GRACE VALLEY RANCH, PHASE 6

ADDENDUM #2

05/16/2025

C4.00

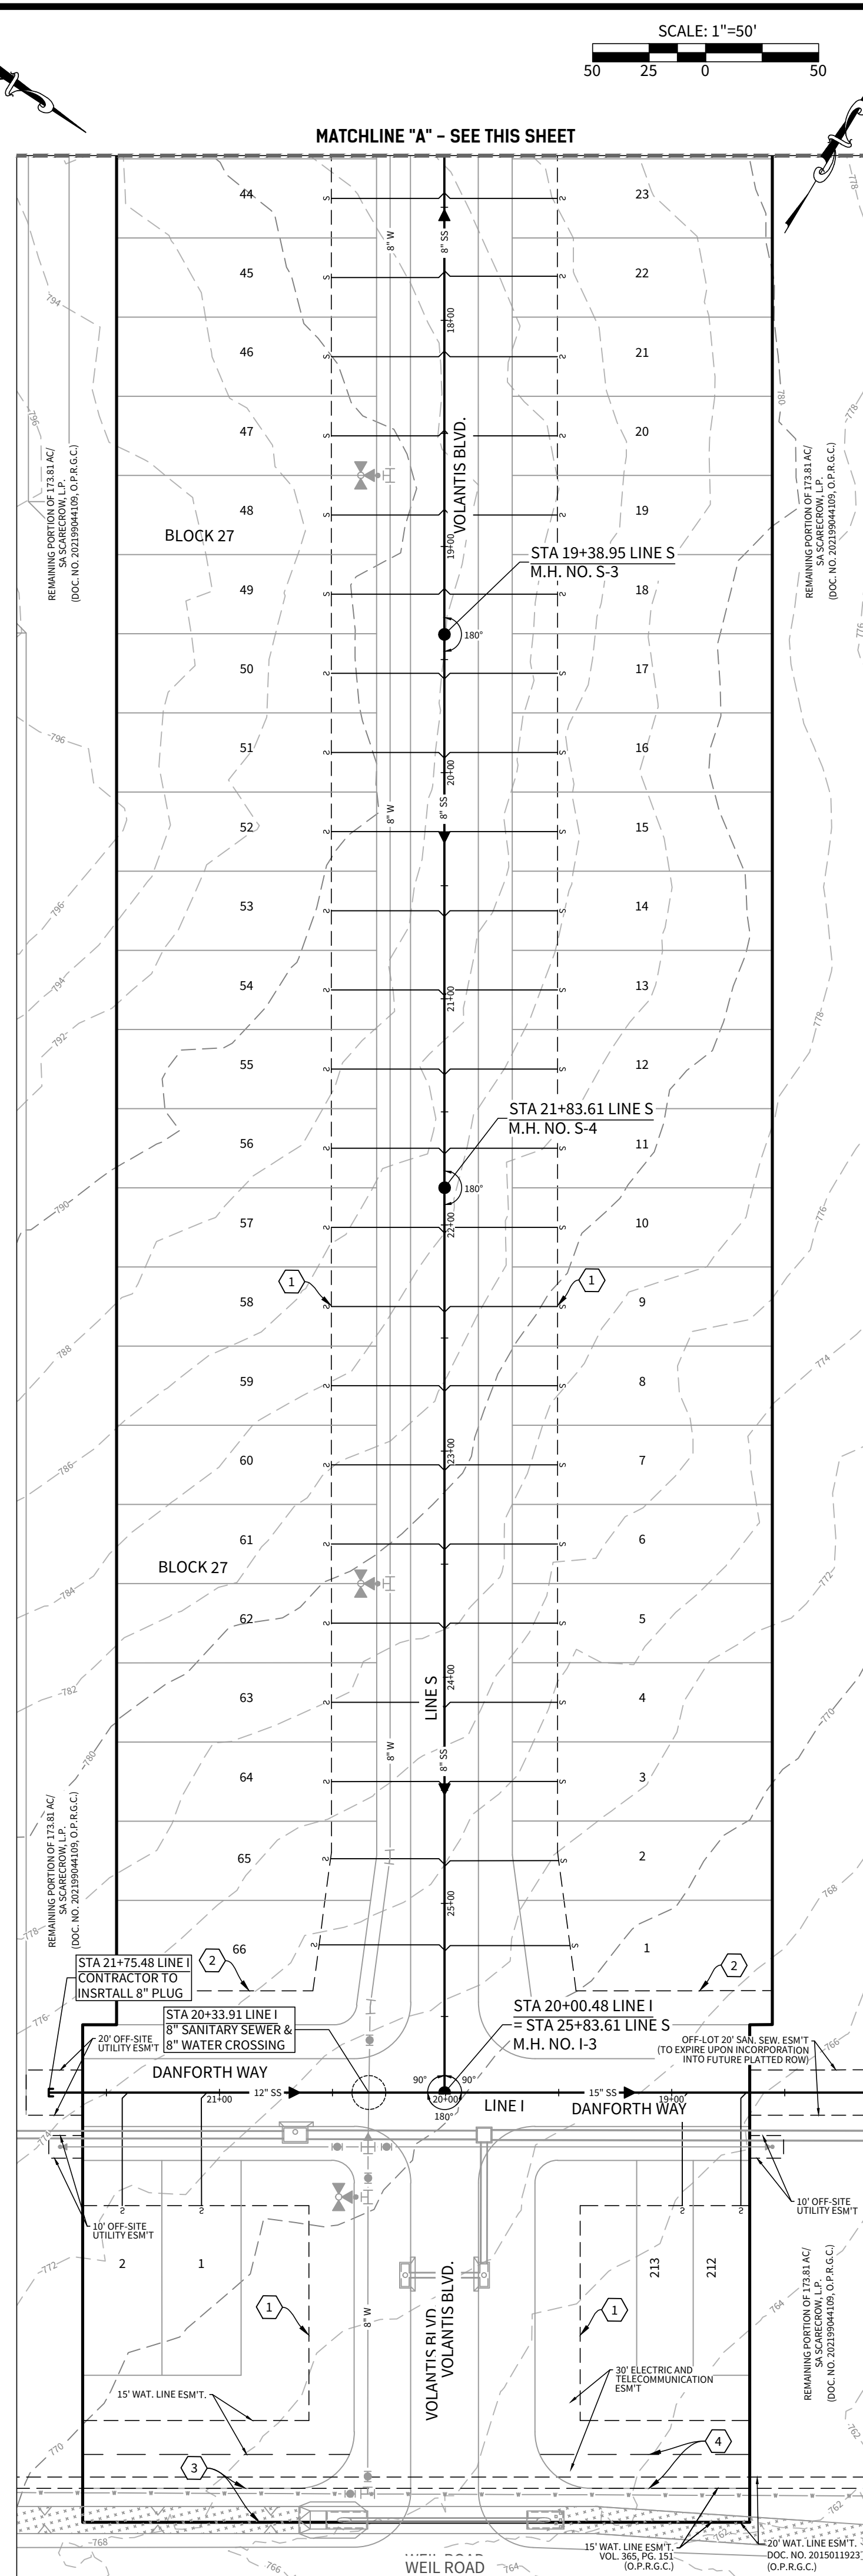
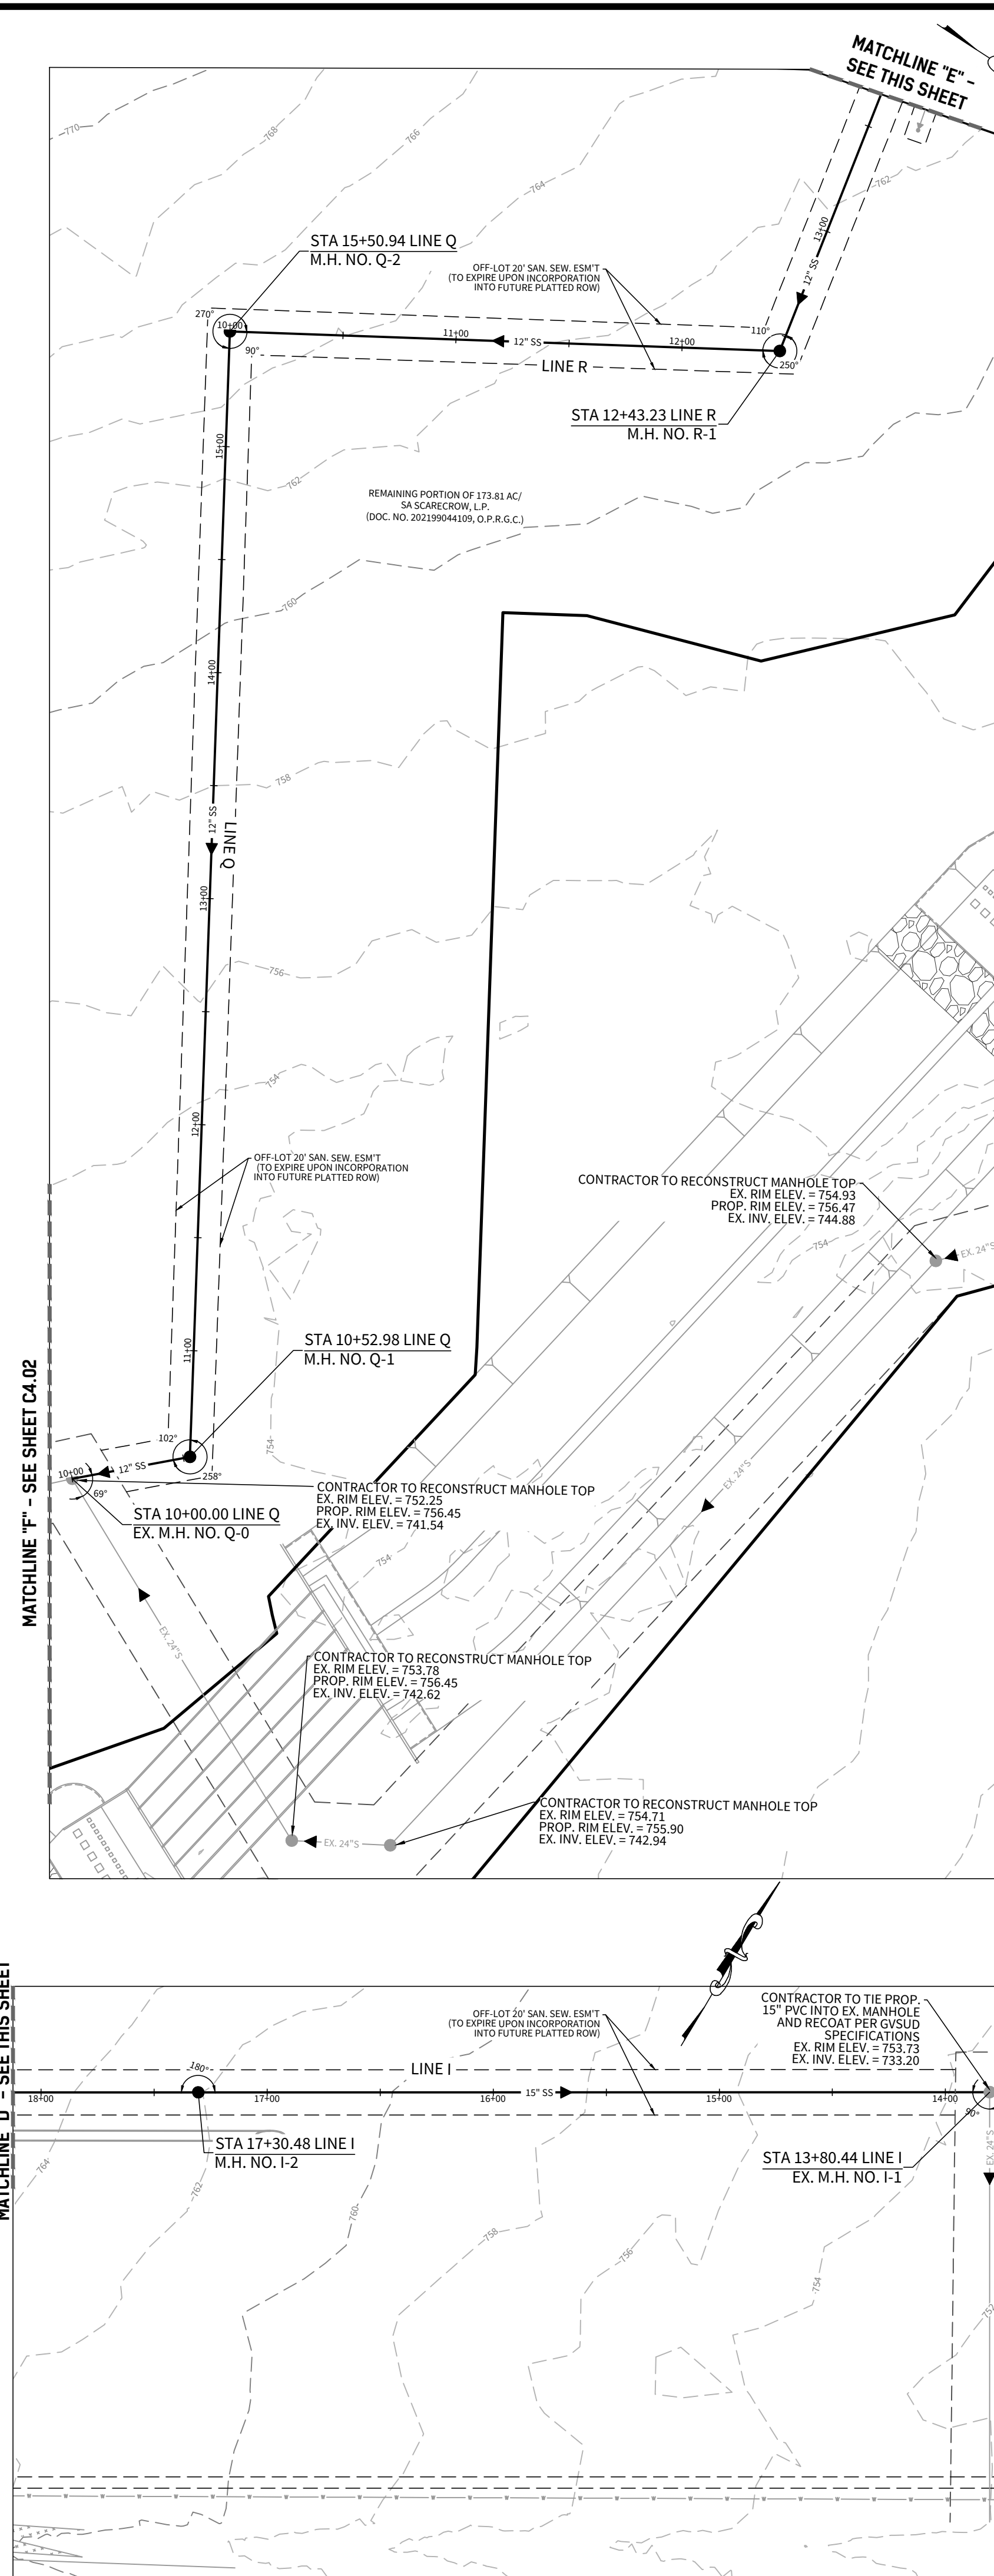
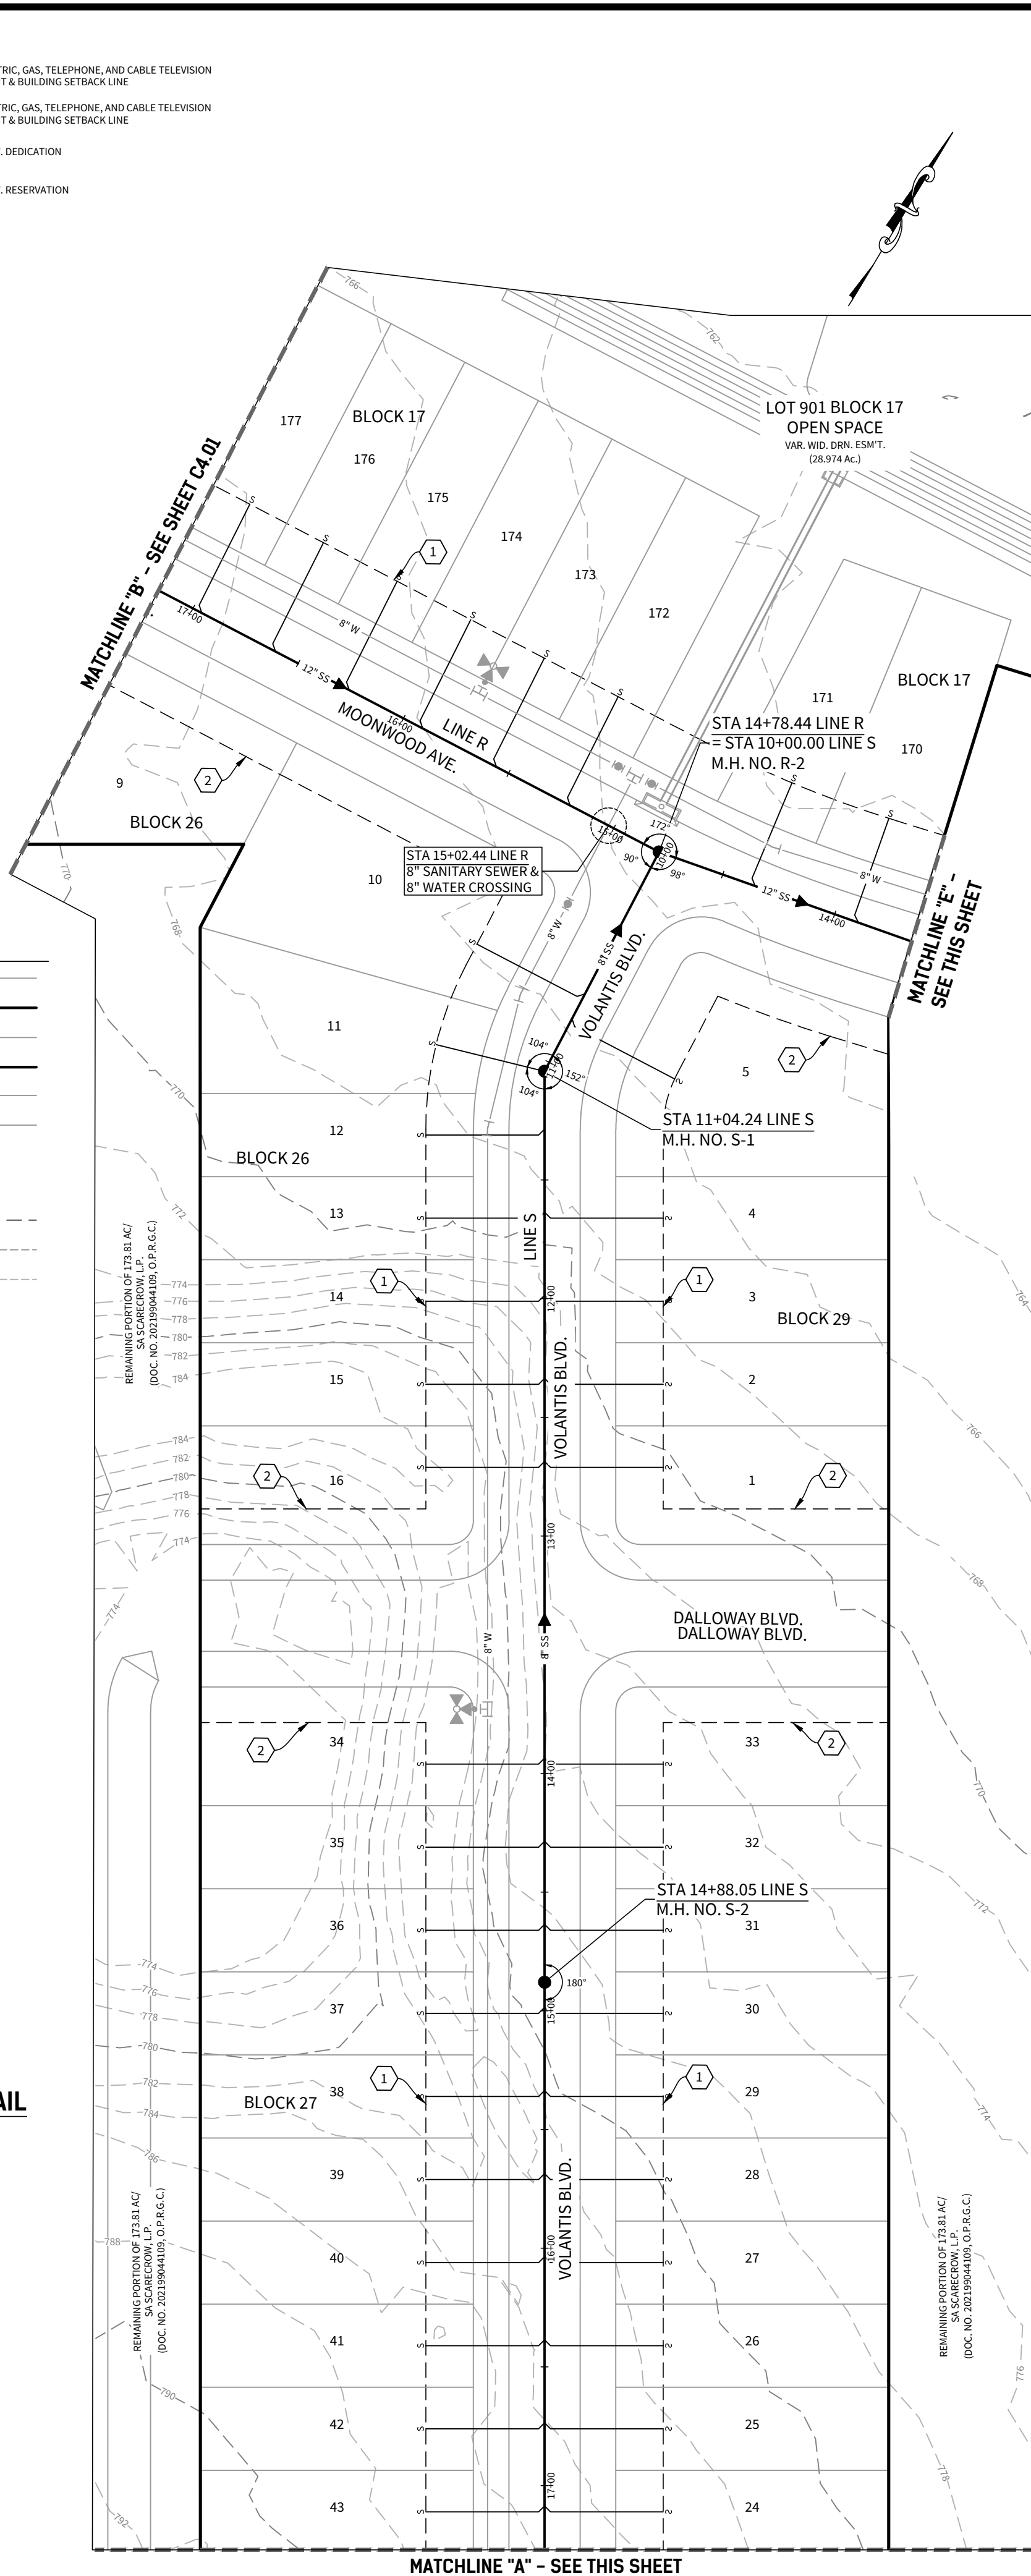
- Question 35** What type of pipe is the existing 6" water main we need to tie into?
- Answer 35** *The existing 6" pipe is PVC.*
-
- Question 36** What are the depths of the 15 existing manholes we are required to reconstruct/adjust, since we need to recoat?

- Answer 36** *The existing manhole inverts have been shown on revised sheets C4.00 and C4.02 included with Addendum #2.*
